Customer	: CU-DAR001 Dart Helicopters Services	Drawing Name	: 350/355 AS X-TUBE FWD
Job Number	: 27826		
Estimate Number	: 12485		
P.O. Number	: N/A	Part Number	: D350748101
This Issue	: 7/5/2006	S.O. No.	: N/A
Prsht Rev.	: NC	Drawing Number	: IIN D350-748 P5 PREL <i>06.07.05</i>
First Issue	: N/A	Project Number	: N/A
Previous Run	: 27825	Drawing Revision	: PREL
	Type : LANDING GEAR	Material	: N/A
Written By	: <i>[Signature]</i>	Due Date	: 7/30/2006
Checked & Approved By	: <i>[Signature]</i> <i>06.07.05</i>	Qty:	1 Um: Each
Comment	: Est Rev: A New Issue 06-07-05 JLM

Drawing Name: 350/355 AS X-TUBE FWD

Part Number: D350748101

DESIGN QP	DRAWN BY QP	DART AEROSPACE LTD HAWKESBURY, ONTARIO, CANADA	
CHECKED #	APPROVED #	DRAWING NO. D350-748-241	REV. C SHEET 1 OF 3
DATE 06.08.14		TITLE CROSSTUBE (AS 350/355 HI AFT)	SCALE NTS
A	06.03.31	NEW ISSUE	
B	06.06.30	ADD D6018-125 & PRIME AND PAINT	
C	06.08.14	ADD CAD PLATING

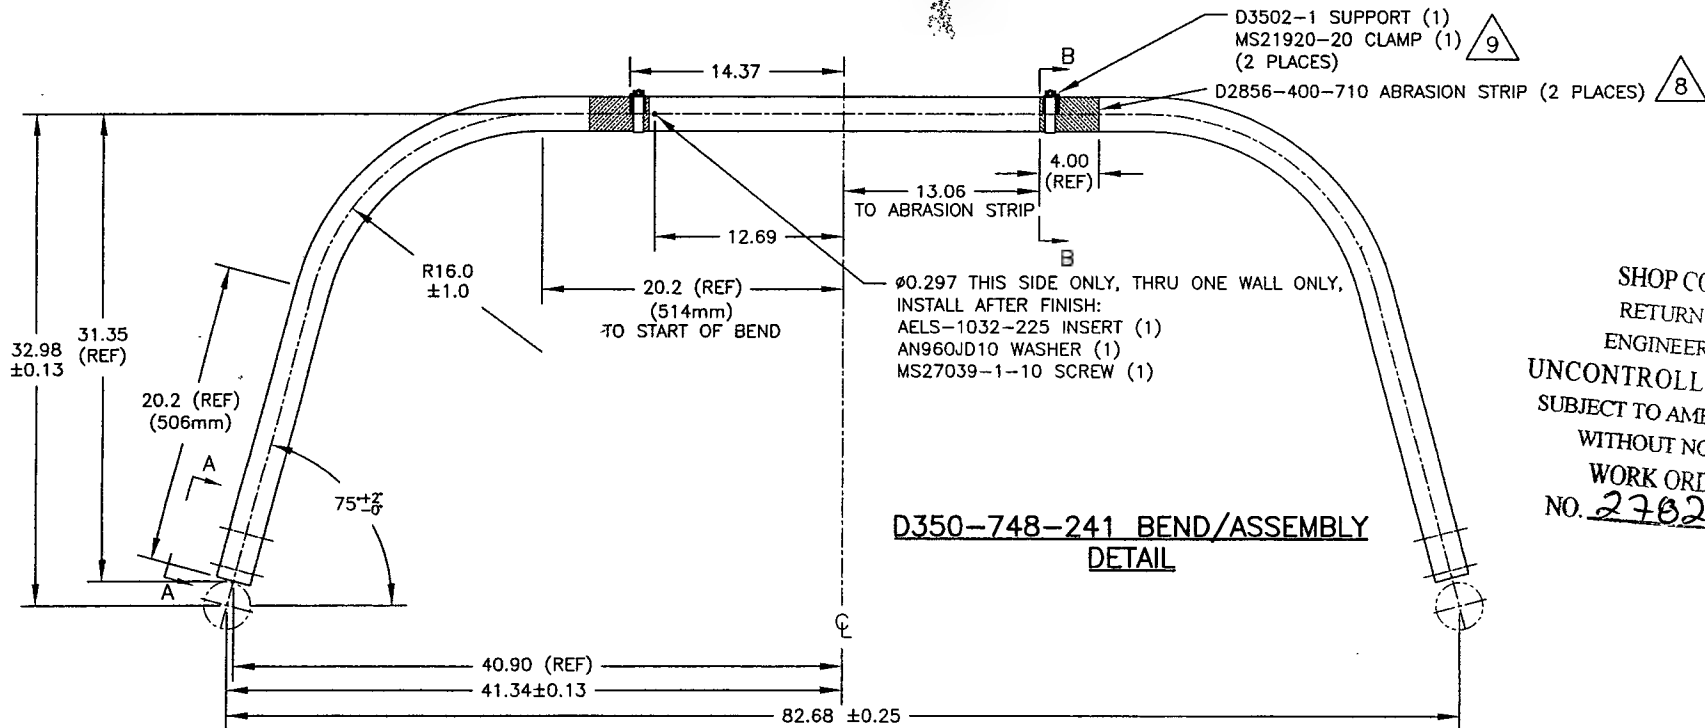
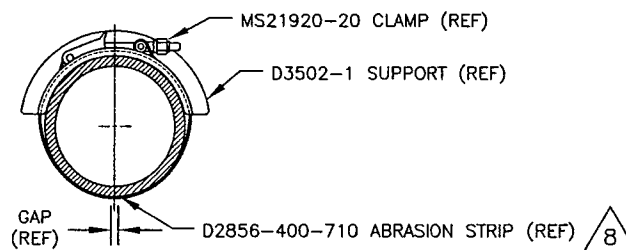
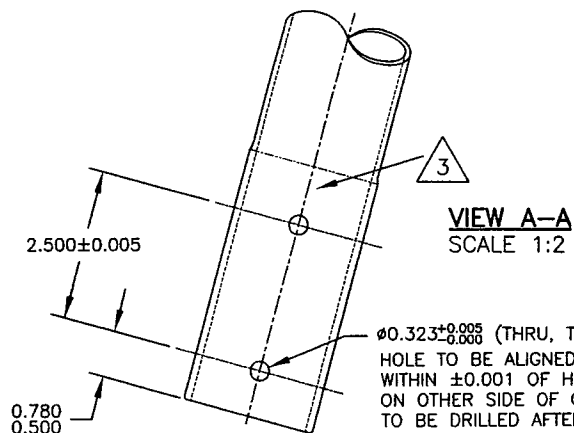
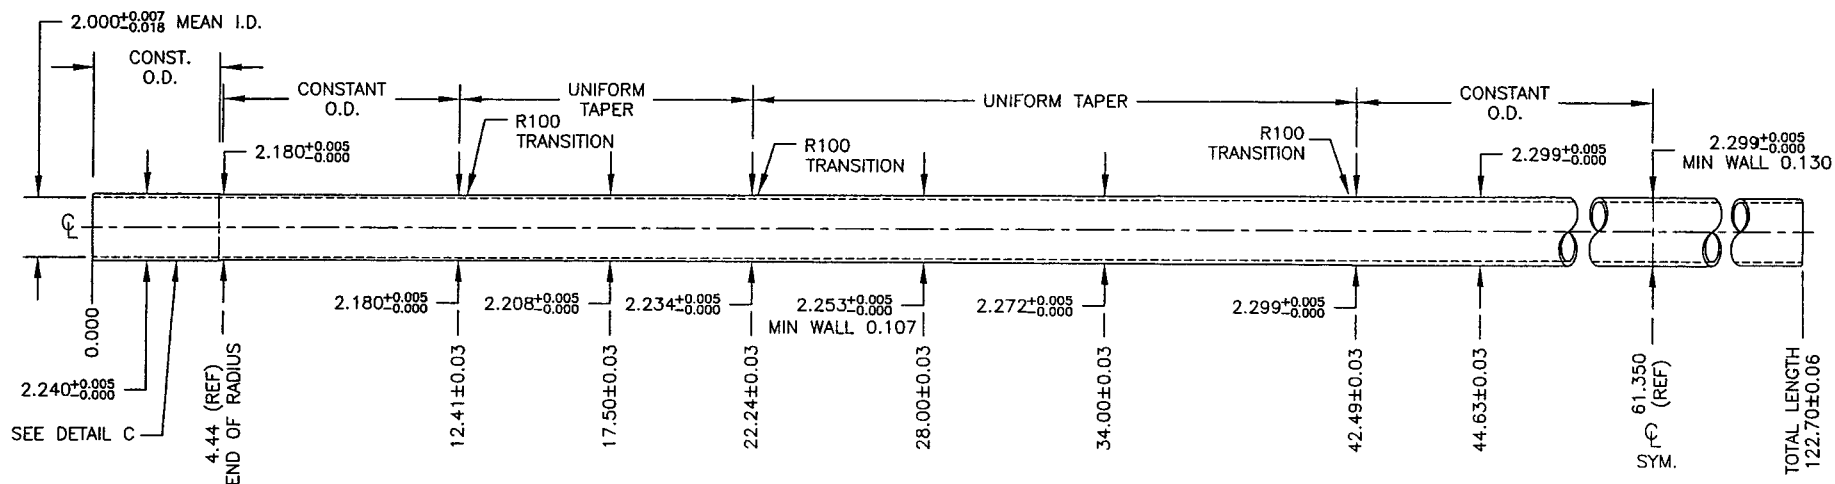
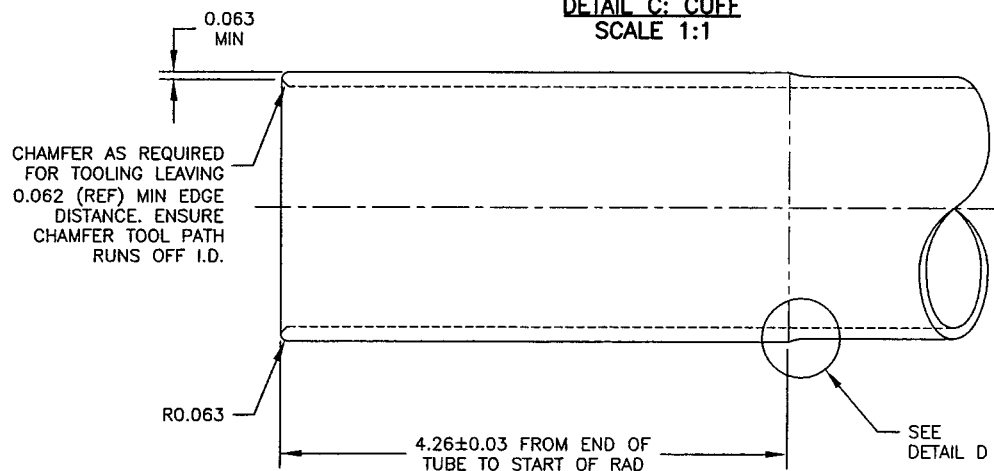
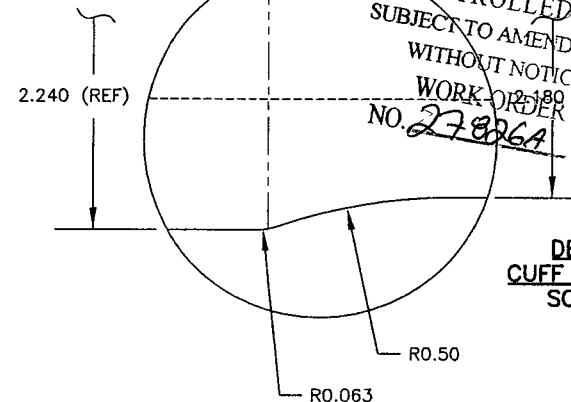
As we discussed, I had some concern about the stress relieving comment on the packing slip because I didn't realize that by heating up the tubes, we would be stress relieving them. We didn't test our crosstubes in a stress relieved condition. The crosstubes we tested had compressive stresses in the tensile stress areas of the crosstube. However, because the highest stress areas are in the unbent portion of the crosstube and because I think we had so much margin in our drop test (no shock absorbers, damaged parts, overloaded, etc ...), my gut tells me that we are OK and I don't think we need to re-test.

-I originally told you that the magnetic particle was done first. That was the plan, but they ended up following the drawing (cad->magnetic). The invoice I sent you gives the correct order the work was done.

-The cad plating was done to AMS-QQ-P-416B (issued 2004 by SAE) instead of the drawing's' QQ-P-416F (issued 1991 by military). I don't see a problem with this since it's a more current issue, and the only reason we specified QQ-P-416F is because that's what the "old" never-used supplier suggested.

-The dims were re-checked after cad plating and the dimensions did not change.

I think the modified CAD plating procedure is acceptable.

I'm glad to hear that we are dimensionally checking the crosstubes after all the heating. I think this step should be added to the work order on receiving inspection for every crosstube.

As we discussed, I think a drawing revision is in order. I think reference to a QSI for the procedure outlined on the packing slip would be best.
